Reference: Work Plan for Sub-slab Vapor Sampling and Source Area Subsurface Investigation
Rodding Cleaning Services
2585 Nicholson Street, San Leandro, CA
Fuel Leak Case No. RO00000020
Versar Project No. 104422.4422.007

Subject: Response to Letter: *Request for Work Plan Addendum; Fuel Leak Case No. RO00000020 (Global ID# T0600101153), Rodding Cleaning Services, 2585 Nicholson Street, San Leandro, CA 94577. Dated 5 October 2011*

Subject: Work Plan Addendum for Sub-slab Vapor Sampling and Source Area Subsurface Investigation
Former Rodding Cleaning Services
2585 Nicholson Street, San Leandro, California
Fuel Leak Case No. RO00000020

**Figure
3**

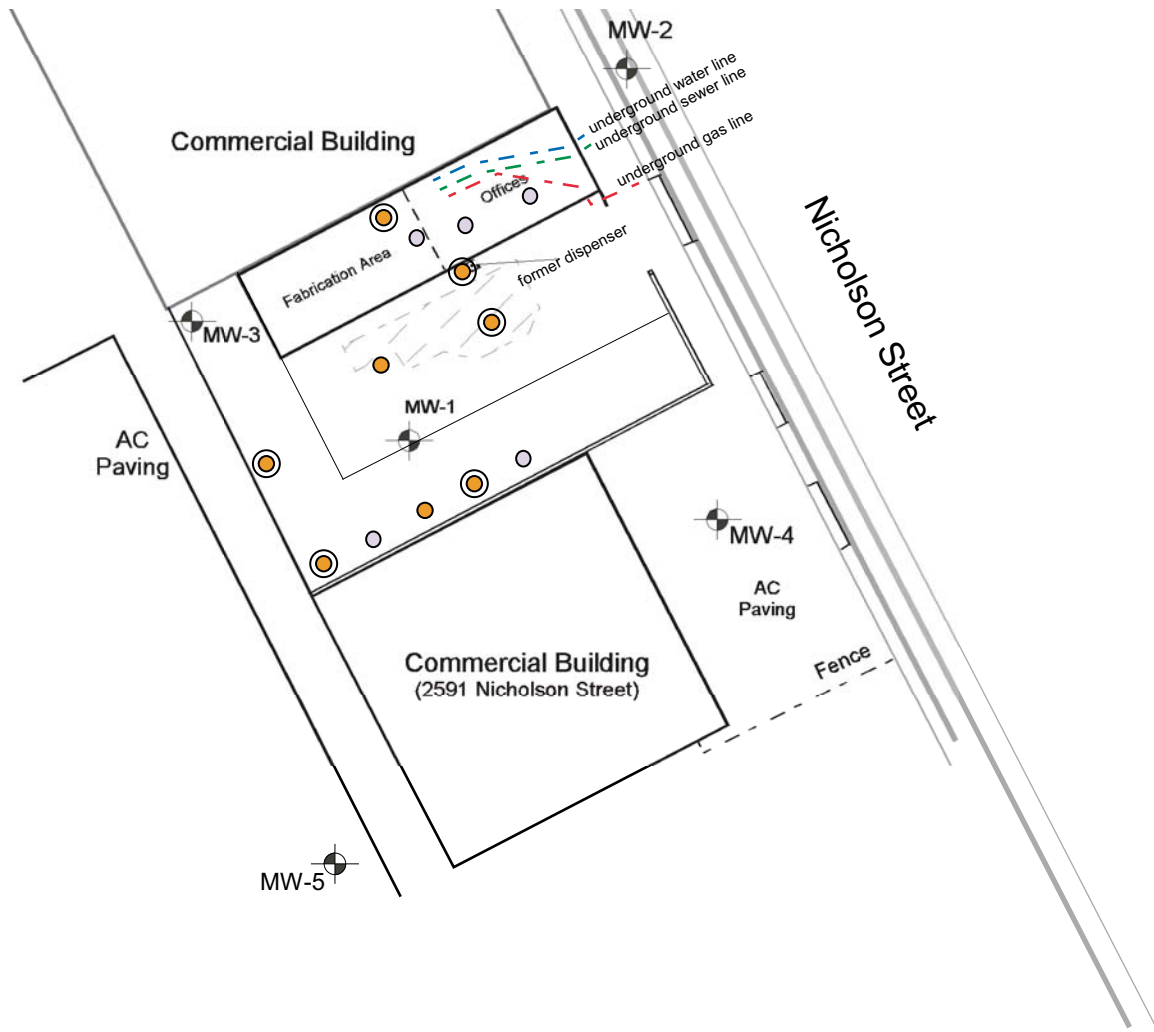
Five (5) sub-slab soil vapor well points are proposed. Three are proposed within the office and fabrication area of the Site, and two are proposed along the property line adjacent to the adjoining building to the south. Underground utilities comprising natural gas, water and sewer enter the offices of the 2585 Nicholson Street building at various locations along the northeast end. Electrical power enters the building above ground. Prior to installing the wells a private utility locator will identify the location of subslab laterals. Figure 3 in Attachment 1 includes the entry points and approximate locations of subslab utilities.

Soil vapor wells are proposed to be installed at the five (5) locations depicted on Figure 3 to a depth of 8 inches below the concrete surface. Each well will be constructed of a six-inch by 0.5-inch stainless steel mesh screen set within the granular sub-base material beneath the concrete apron, with a 4-inch long, 0.25-inch diameter Teflon tube extending through the concrete slab to the surface. Each screen is set within a sand pack comprising #2/12 sand with hydrated bentonite granules between the sand and concrete slab. The wells will be inserted into one-inch diameter borings cored with a concrete bit through the slab. The surface will be completed within the concrete slab using a flush-mount fixture with O-ring seal. The surface mount is set in cement. A diagram of the sub-slab vapor well system is attached; Versar's well installations will include the described 4-inch Teflon tube and mesh screen (with sand pack) placed within granular base material beneath the bottom of the slab.
